Remarks

Regarding the Amendments to the Drawings, Applicant has included replacement informal drawings, and annotated sheets of informal drawings showing the changes to Figures 1 to 6, in the Appendix. Applicant will submit replacement formal drawings upon the Examiner's approval of these changes.

FIG. 1

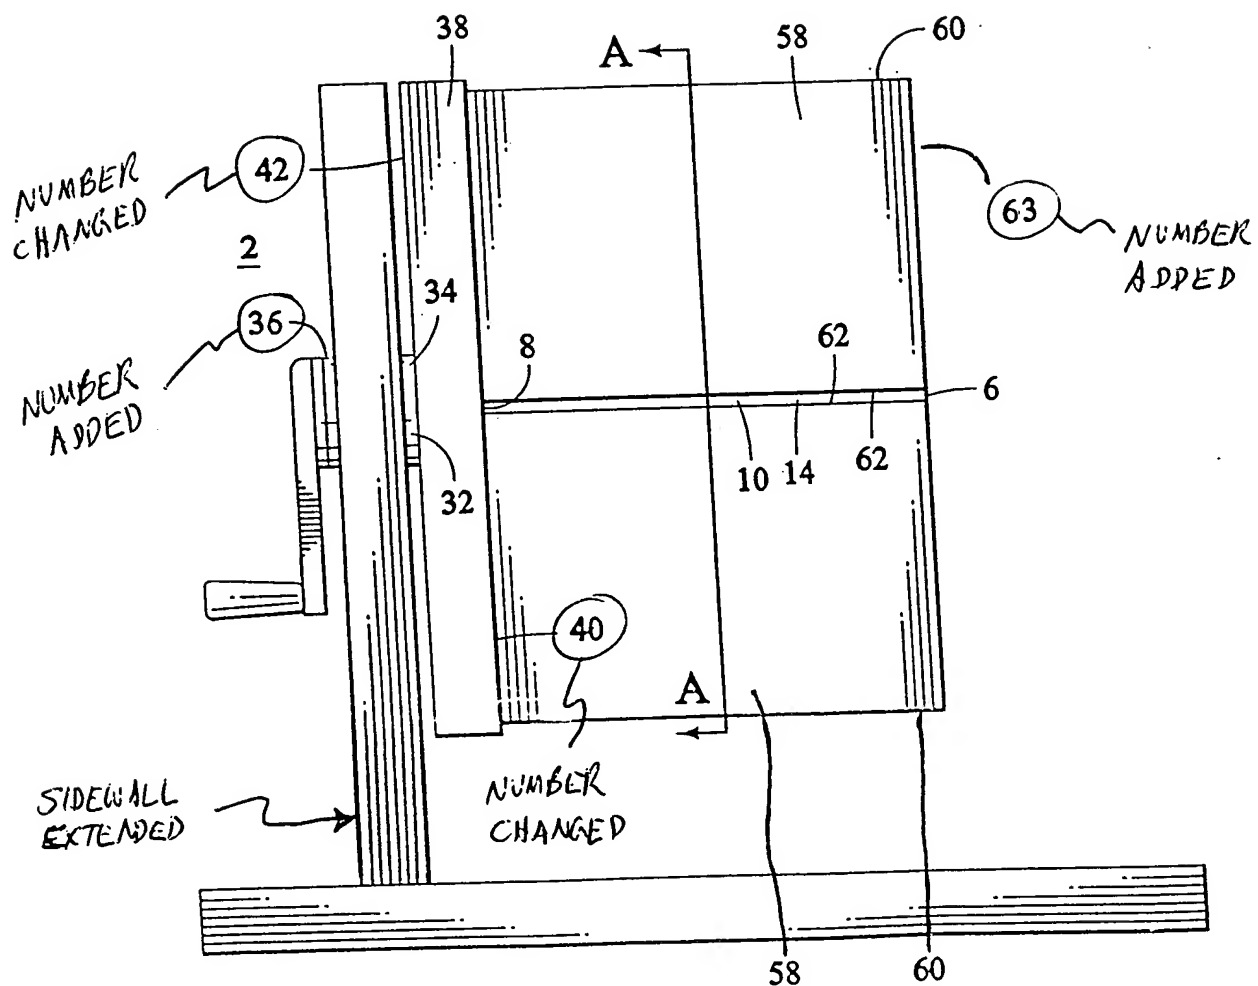
Referring to the specific changes to Figures 1 and 2, previously omitted reference number 63 was added to Figure 1, reference number 36 (from Figure 2) was added to Figure 1, and reference numbers 40 and 42 were reversed in both Figures 1 and 2. These corrections are fully supported in the original specification at Paragraphs 0027 ("Two heatsinks 58, each having a top side 60, a bottom side 62, and a front side 63 ...") and as described above regarding the Amendment to Paragraphs 0025, 0027, 0033, and 0038 of the Specification.

Figures 1-6 have also been corrected to more accurately show the relative dimensions of the sidewall 22 with respect to the base 16. This correction to the drawings would be apparent to those skilled in the mechanical arts to allow unencumbered rotation of heatsinks 58 and/or block 98 having the square cross-section shown in Figures 3 and 5. Of course, if the heatsinks/block were drawn to have a round cross-section, this correction would not be required. This correction is also supported throughout the original specification, particularly at the following locations:

FIG. 3

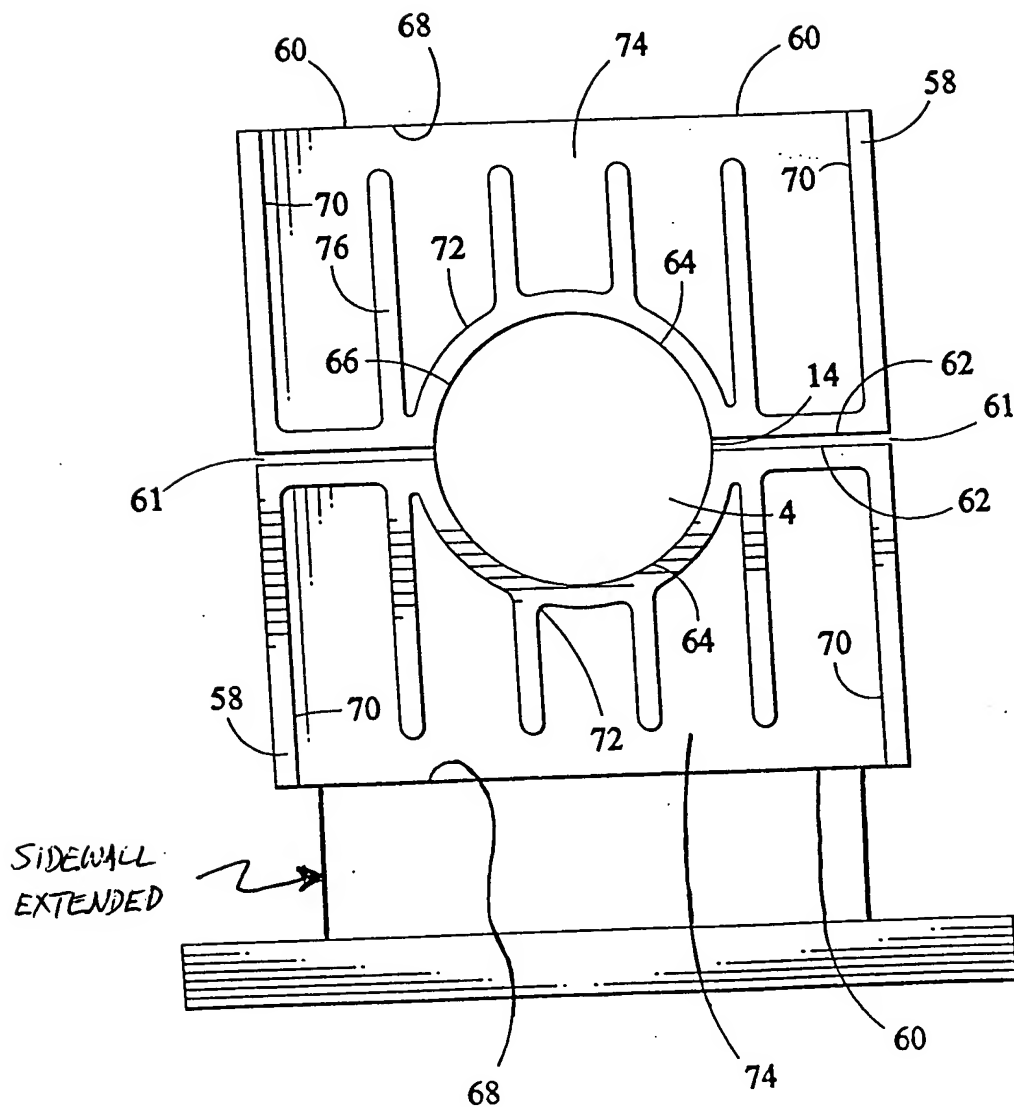
Regarding the Amendments to Paragraph 0025 of the Specification, Applicant submits that the language of amended Paragraph 0025 more clearly and consistently describes the invention, particularly as shown in Figures 1, 2, and 3. Since Figure 3 is a “front” sectional view of an embodiment taken along the line A-A of Figure 1, per Paragraph 0015 of the original application, the “front side” of the liquid cooler 2 of Figure 1 is the right-hand side. For consistency and clarity, the “front side” of rotating connector 38 of Figures 1 and 2 should also be the right-hand side of the figures, which have been corrected accordingly. This front/rear orientation is also supported in the original application at Paragraph 0017 (“FIG. 5 is a front sectional view of an embodiment taken along the line B-B of FIG. 4;”) and at Paragraph 0043 (“Referring now to FIG. 7, ... a membrane 96 is used in lieu of the front face of the heatsink 58 ...”) Therefore, no new matter has been introduced into the application by this amendment.

Regarding the Amendments to Paragraph 0028 of the Specification, Applicant submits that this amended language more accurately and precisely describes the invention, particularly as shown in Figure 3. Since the term “coplanar” typically means “lying or occurring in the same plane”, and since the inner portion 64 of the bottom side 62 of the heatsink 58 is actually shown as a curved surface in the embodiment of Figure 3, the term “adjacent to and in contact with” is more appropriate. No new matter has been introduced into the application by this amendment, since the change is fully supported in the figures as filed (e.g., Figure 3), in the claims as filed (e.g., Claim 1), and in the specification as filed (e.g., Paragraph 0034).
